Reviewed for Code Compliance
Inspections Division
Approved with Conditions

Front view Duct
Through Chase way

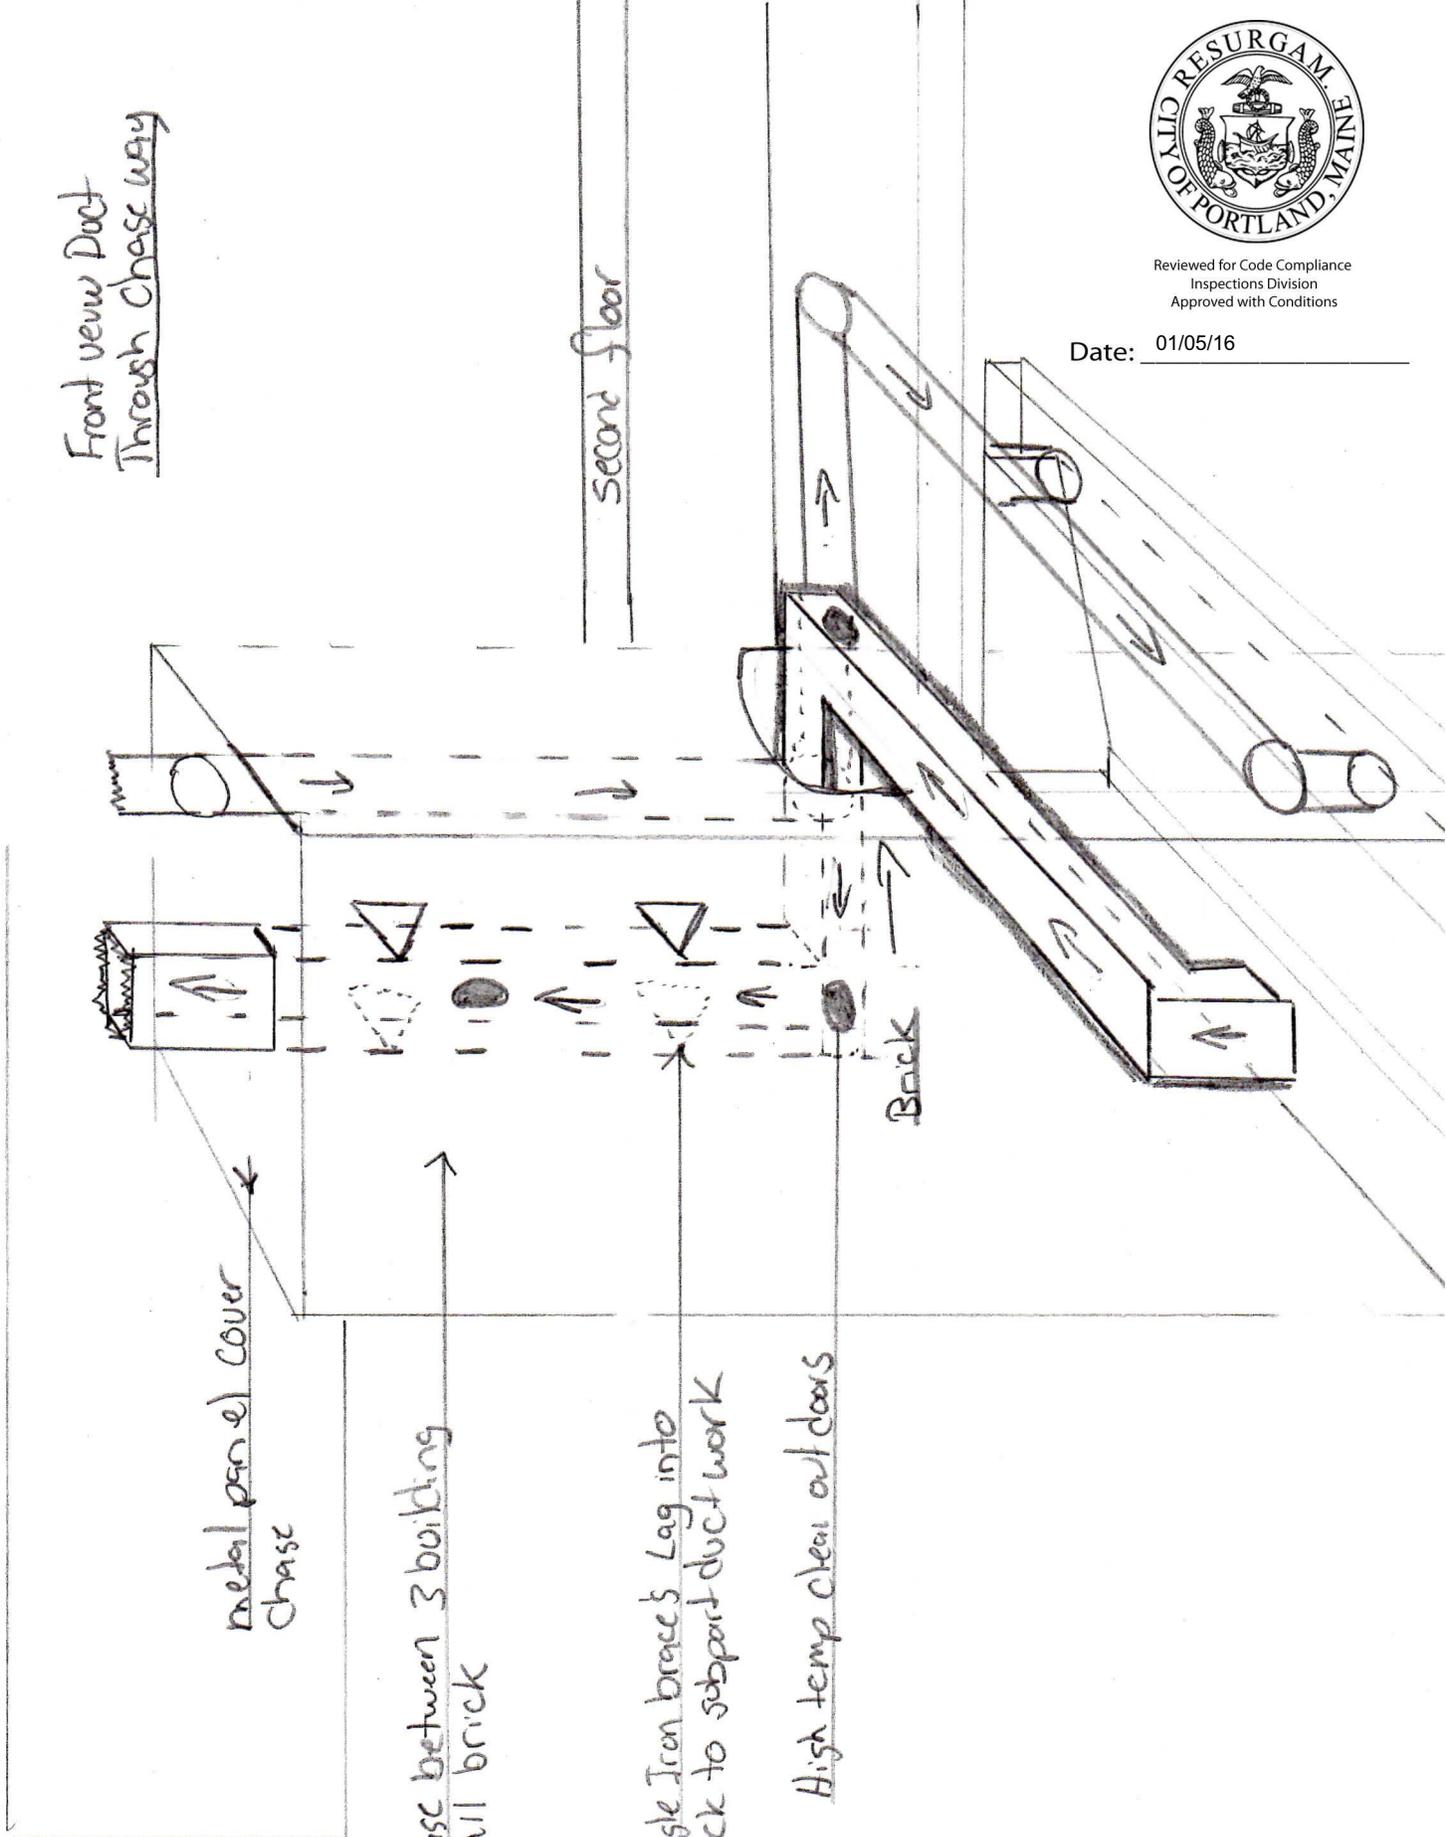
metal panel cover
Chase

Chase between 3 building
is all brick

Angle Iron brace's Lag into
brick to support duct work

High temp clean out doors
